BUILDING PERMIT REPORT

DATE: 1 MAY 2001 ADDRESS: 80 Verrill St CBL: 300-B-029

REASON FOR PERMIT: Single Family dwelling / attached private garage.

**CITY OF PORTLAND, ME
BOCA 1999 Plan Review Record
One and Two Family Dwelling**

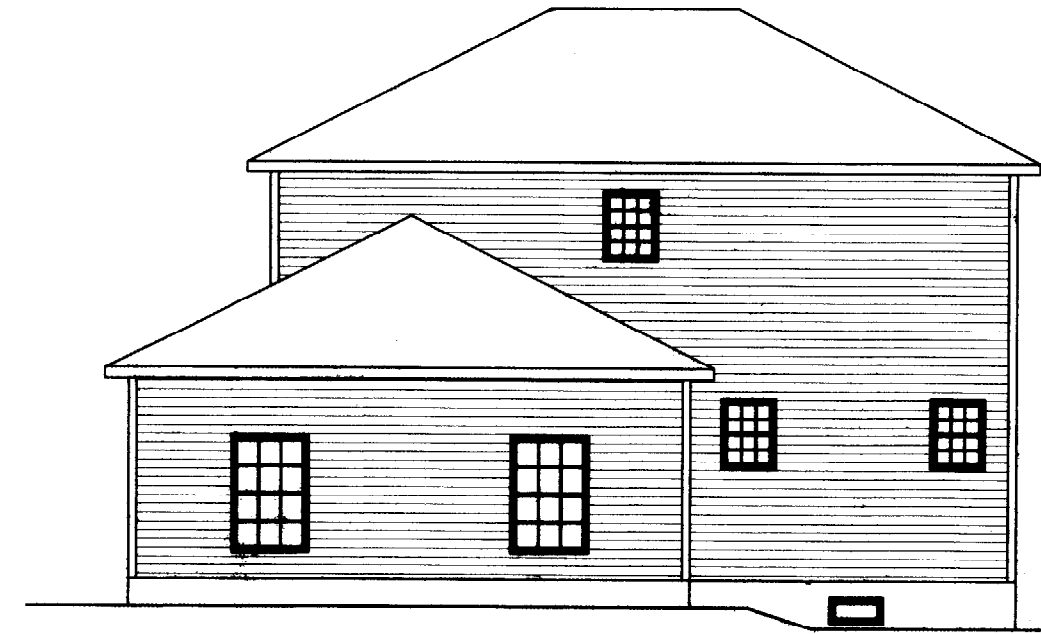
- 1 This permit is being approved on the basis of plans submitted. Any deviations shall require a separate approval before starting that work.
- 2 Separate permits shall be required for future decks, sheds, pools, and/or garage.
- 3 No decks are shown on your submitted plans. No decks are being approved. Any future decks shall required a separate permit PRIOR to construction.
